PLANNING APPLICATION NUMBER: P08/0131

Type of approval sought		Full Planning Permission	
Ward		BELLE VALE	
Applicant		Mr S. Broadway	
Location:	34, HADEN HILL ROAD, HALESOWEN, HALESOWEN, B63 3NQ		
Proposal	DEMOLITION OF EXISTING DWELLING AND ERECTION OF 2 NO. 3 BEDROOM SEMI-DETACHED DWELLINGS		
Recommendation Summary:	APPROVE SL	JBJECT TO A 106 AGREEMENT

PLANNING DRAWINGS FOR 34 HADEN HILL ROAD HALESOWEN DRAWING NO SID/002 REVISION A 28.02.08

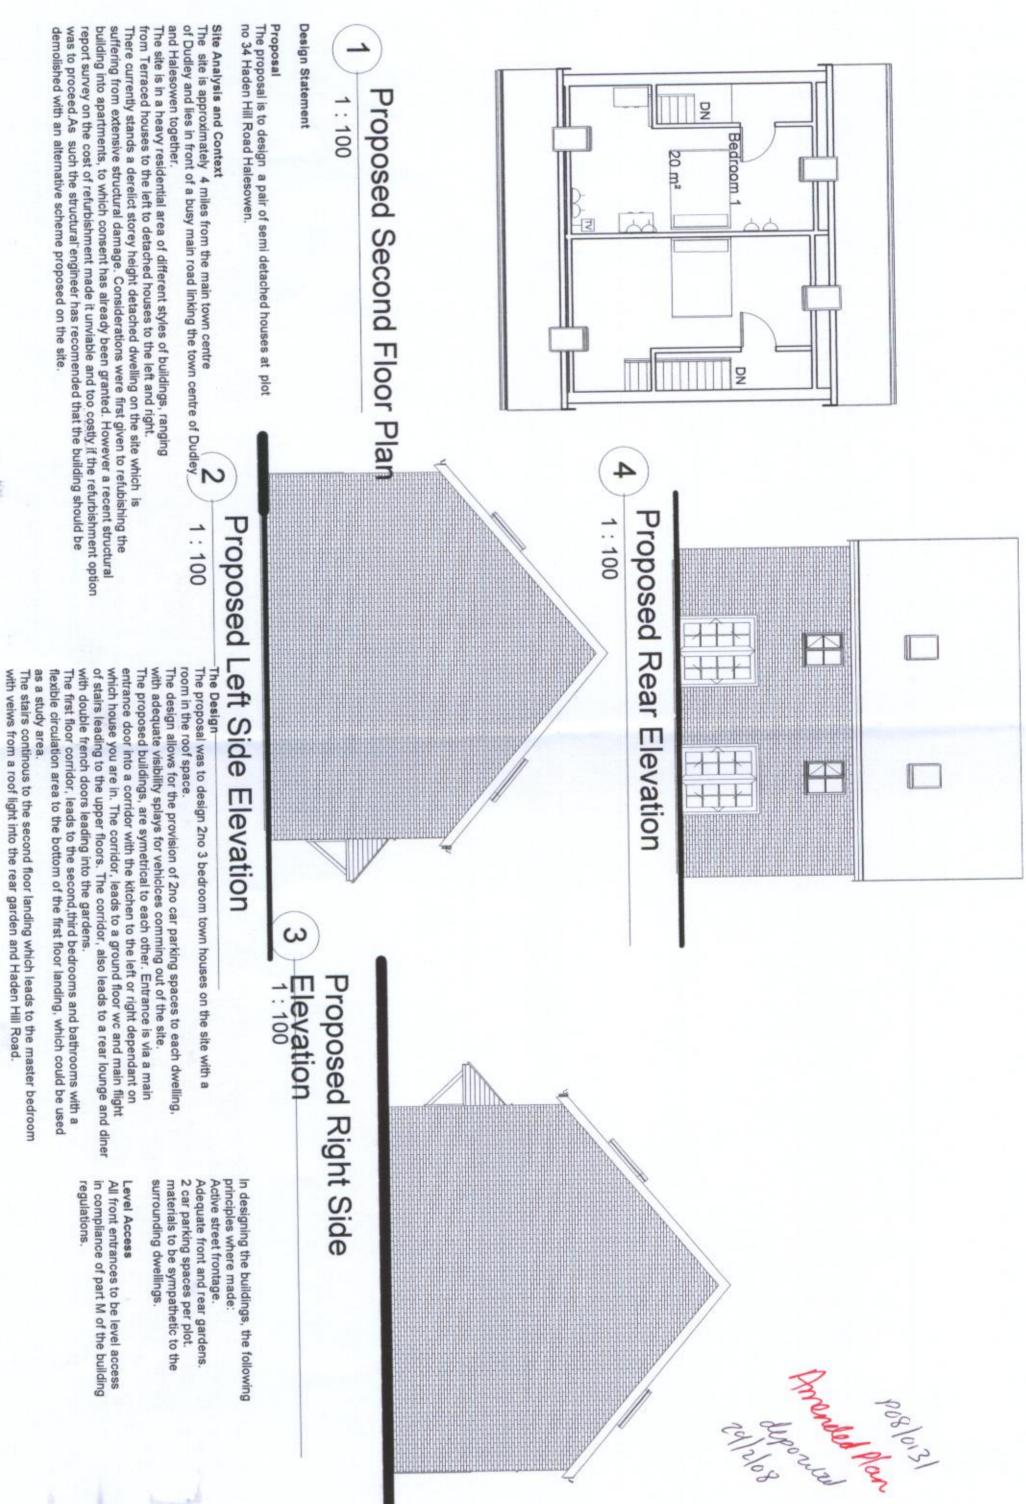
The proposed semis are shown set back in the site with a forward building line similar to that of the adjoining dwellings. This set back also helps in removing the expansive and visually prominent blank gable on the northern side of the existing dwelling from the streetscene. In addition, the proposed dwellings also present a similar ridge line to those dwellings. The design of the proposed dwellings is therefore satisfactory.

The proposed semis are shown with a rear building line similar to that of the adjoining existing dwellings. That rear building line is set further back than that at no. 32 Haden Hill Road. However that property has a garage alongside the shared boundary, and, although the occupiers of no. 52 have had permission to erect a 2 storey side and rear extension in place of that garage (P07/2211), the windows to the kitchen diner and bedroom at the rear of this approved extension, will not be unduly impacted upon by the proposed semis. The amenity of existing occupiers will not be unduly prejudiced.

The applicants have amended the layout plans, in part, in response to the views of the Group Engineer. The relevant amendments show the plots to be set back into the site to allow for more manoeuvring and wider spaces in front, including more space for pedestrian circulation. There is now sufficient manoeuvring space so that once the rearmost of the tandem spaces (nearest to the highway) are vacant, cars within the two spaces near to the front of the building can reverse into that vacant space and egress the application site in a forward gear.

- 23 An existing access is proposed to be used, from which vehicles parked in association with the existing house are likely to have used to reverse out onto the highway. Vehicles parked in front of numerous houses further north along Haden Hill Road also have to reverse out onto the highway in similar circumstances to the proposed dwellings.
- 24 Given the above considerations, and the amendments to the layout, it is considered that the proposal will not significantly impact on highway safety, particularly over and above the existing situation.

- 12. The front part of the boundary wall between the application site and no. 32 Haden Hill Road shall be reduced in height to 600 mm, as shown on the approved plans, prior to the occupation of the development hereby approved. The affected part of the boundary wall shall be maintained at a height no greater than this for the life of the development.
